North Bay at Lake Woodmoor

Final Drainage Report

HR Green Project No: 2404118

EDARP File No.: SF263

Norhtbay - 100-yr WSE Along The Proposed Driveway

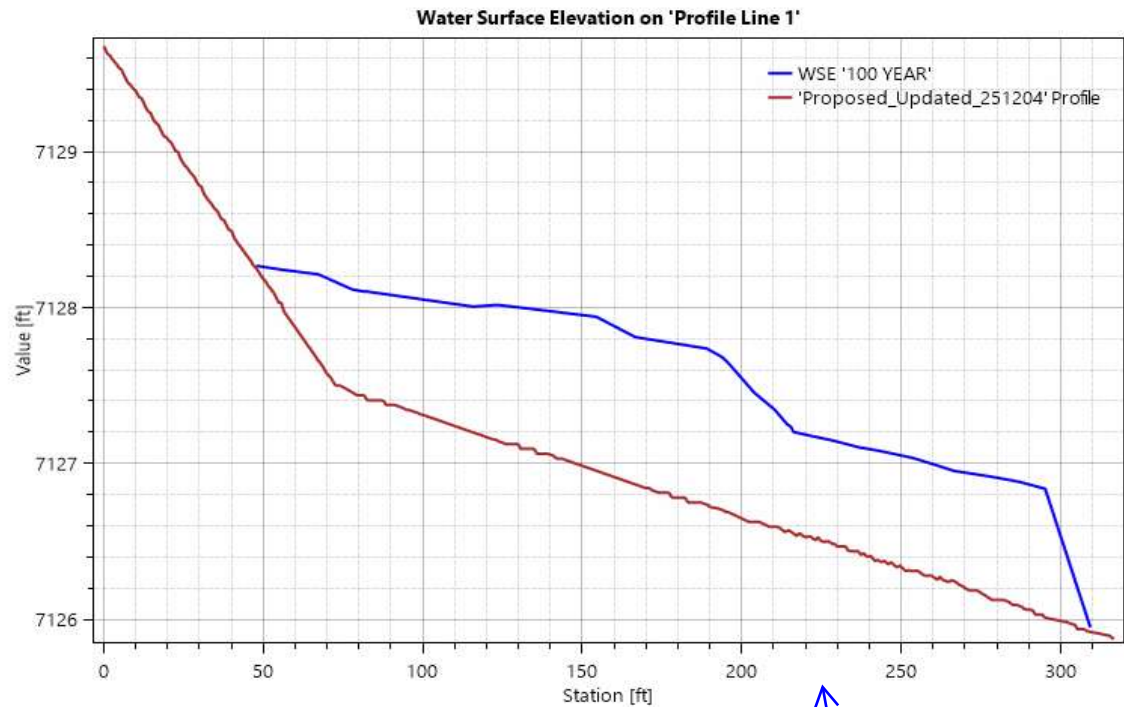
Show these elevations on the drainage plan and CDs

Northbay at Woodmoor Plan: Proposed 1/26/2026

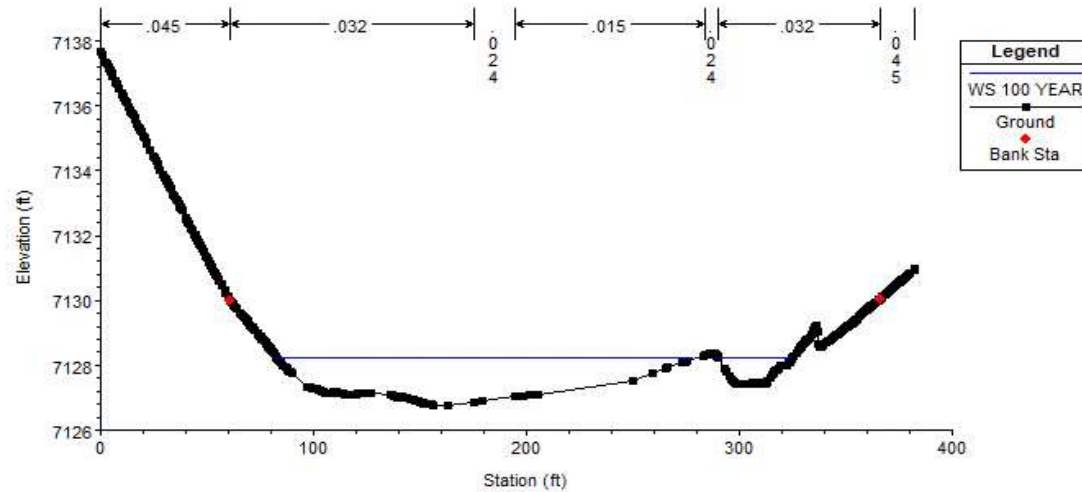
Provide images of floodplain limits with beginning and total road overtopping

NORTH BAY AT LAKE WOODMOOR
WATER QUALITY PLAN

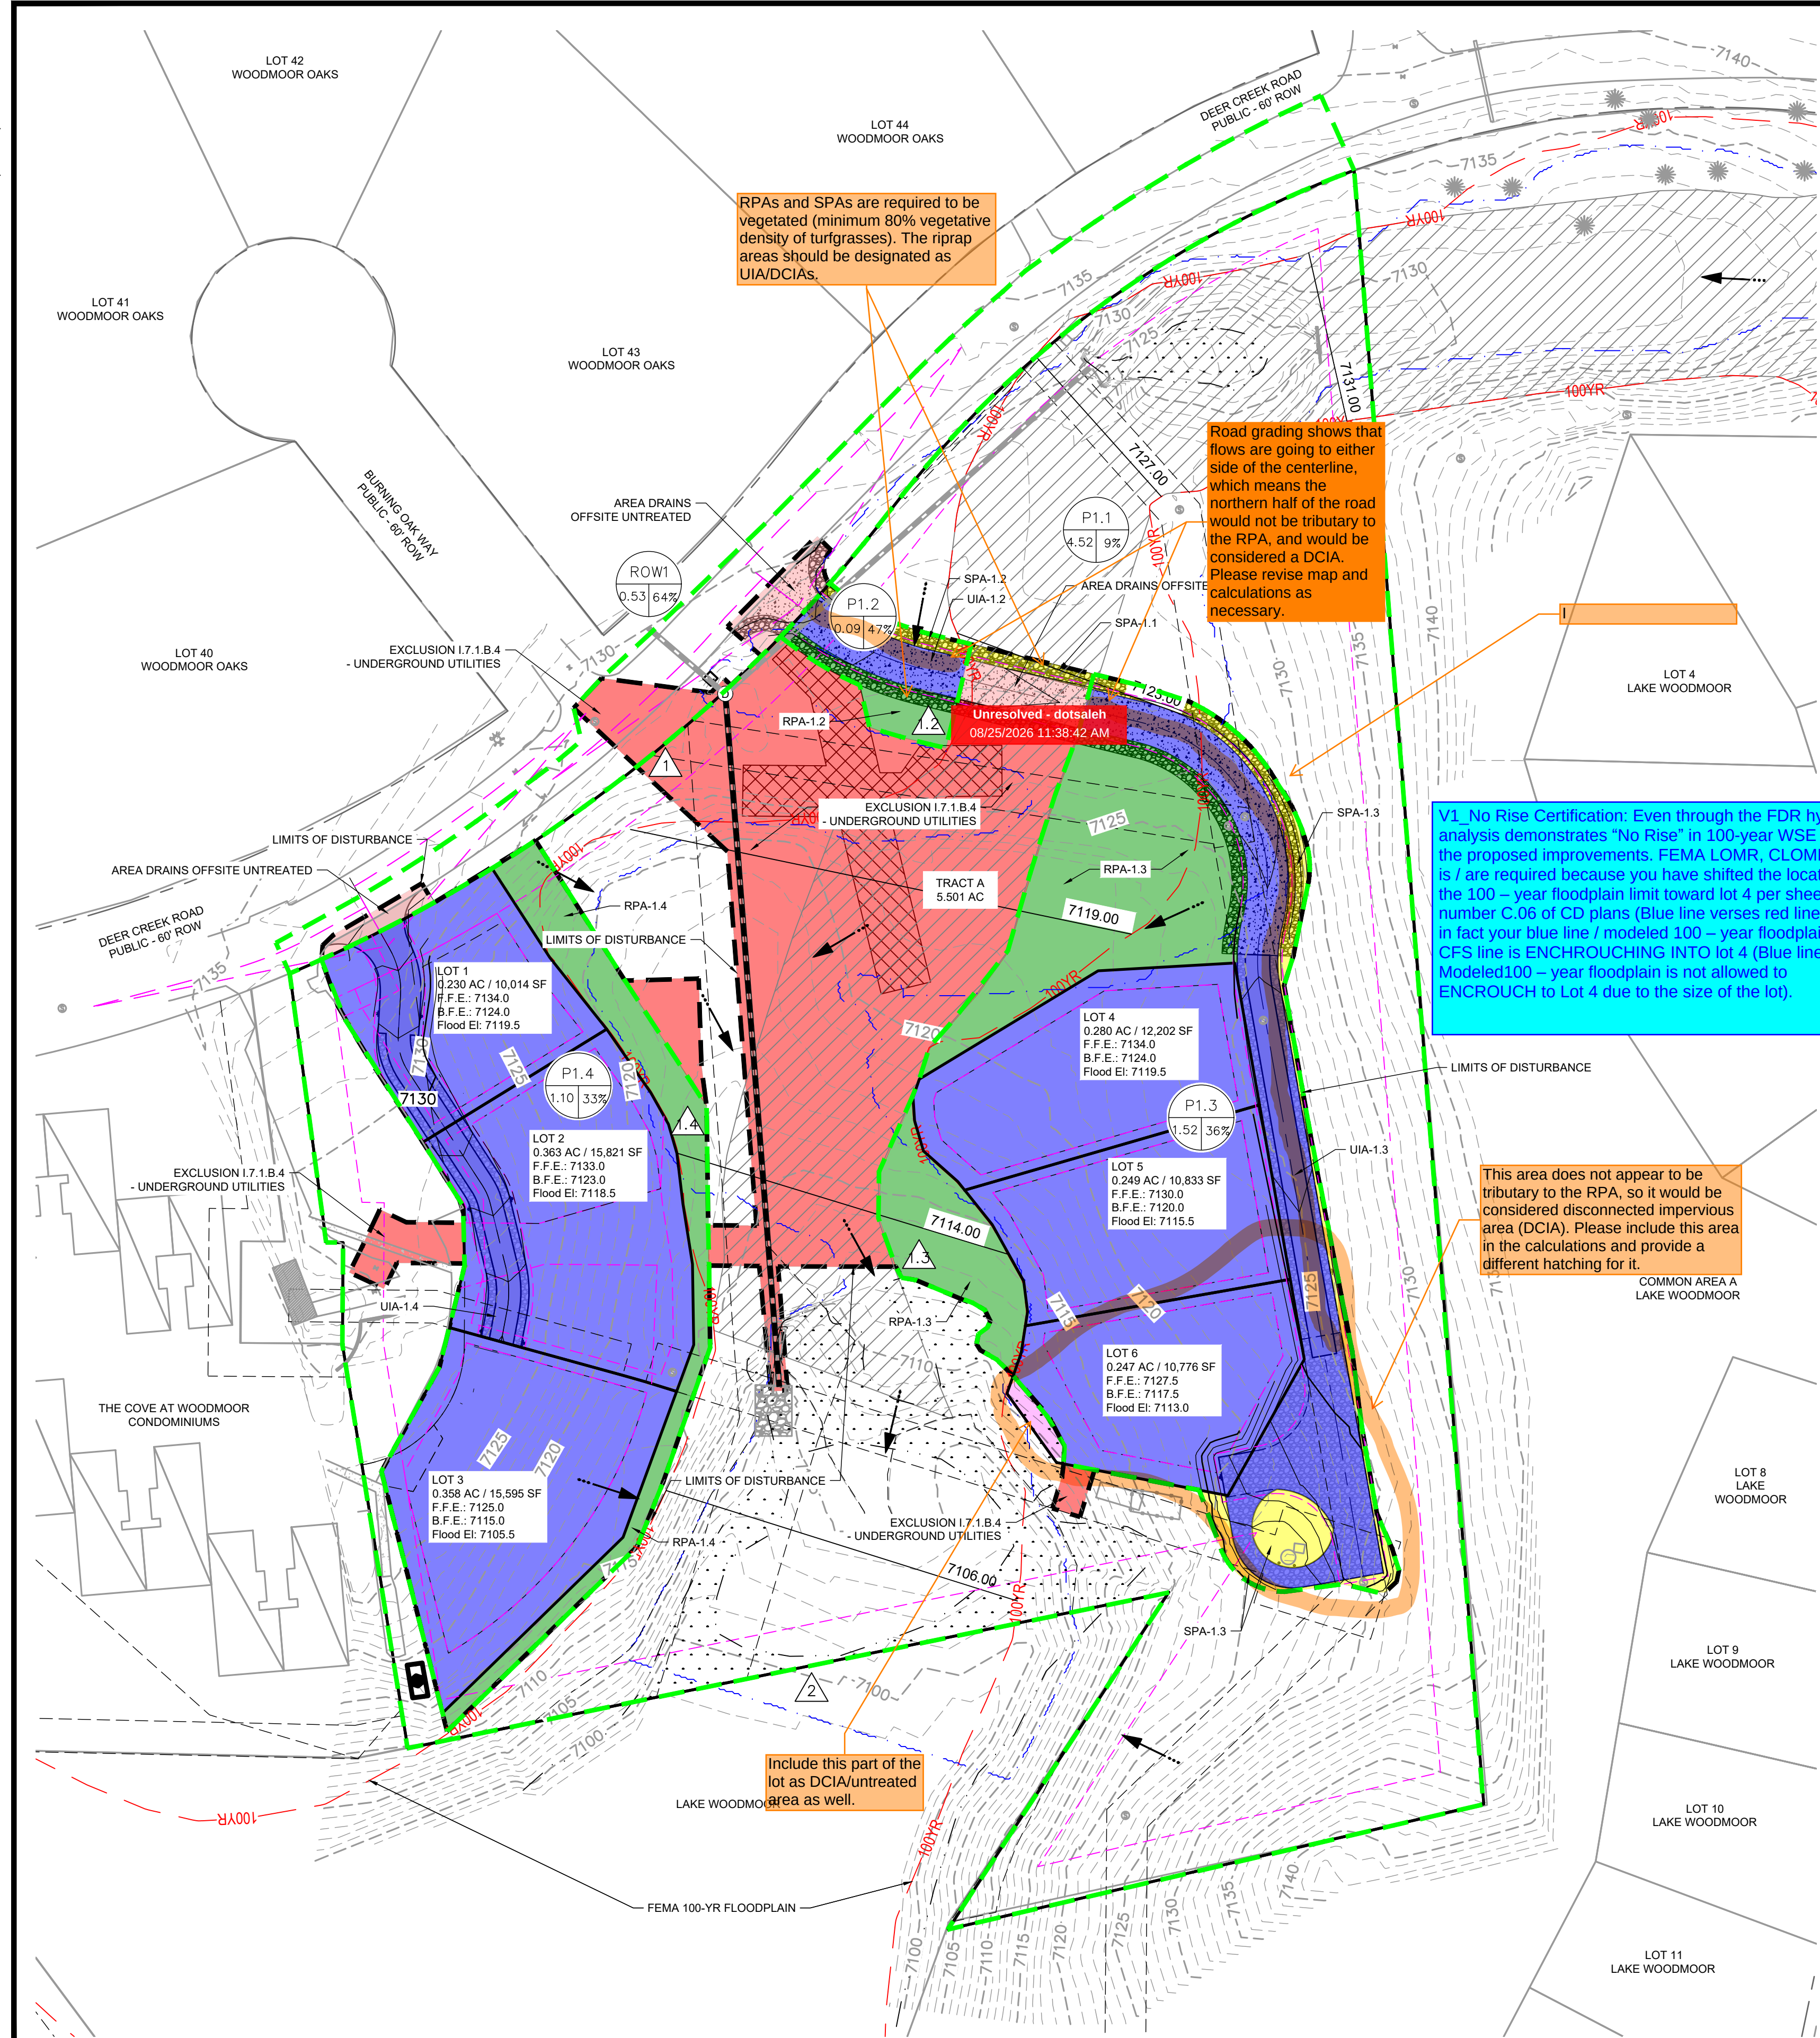
The disturbed areas on the WQ map and WQ table do not match. Please revise.
